Comment Report

75-7410

Reference Map: Place of Use and Point of Diversion

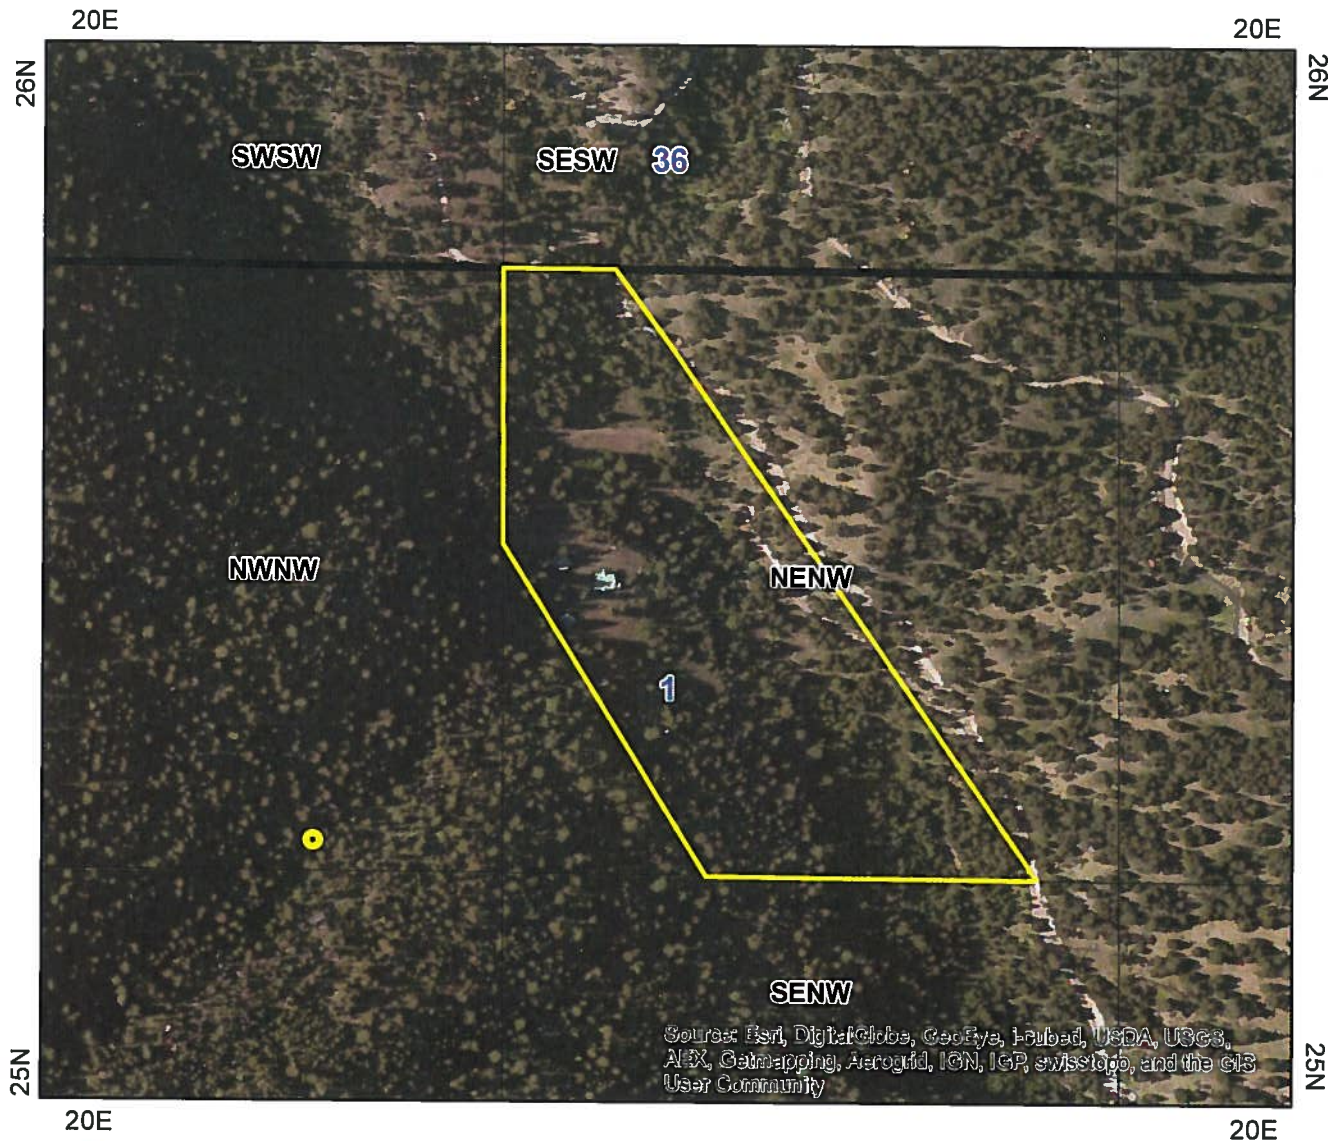
Comment: POD location taken from USFS special use permit map.

Comment: POU location verified from USFS special use permit. Actual POU is within the Gambler Placer Mining: Survey #3467. The location of the domestic structures seems to fall within the NENW of Section 1 despite that it was permitted for the NWNW of section 1. However, since the true legal description is Survey #3467, an amended claim is not required. The shape file linked to this right is not the entire Survey #3467. I cut out the section of Survey #3467 that contains the domestic structure and is within the NENW of section 1.

Comment: USFS Special Use Permit confirms diversion of water and describes delivery system. "...water collection system consisting of 3 foot in diameter "sink" that serves to collect water to fill a 7 ft x 4ft x 4 ft buried concrete cistern that holds approximately 750 gallons of water and 390 feet of buried 2 inch PVC pipeline. "
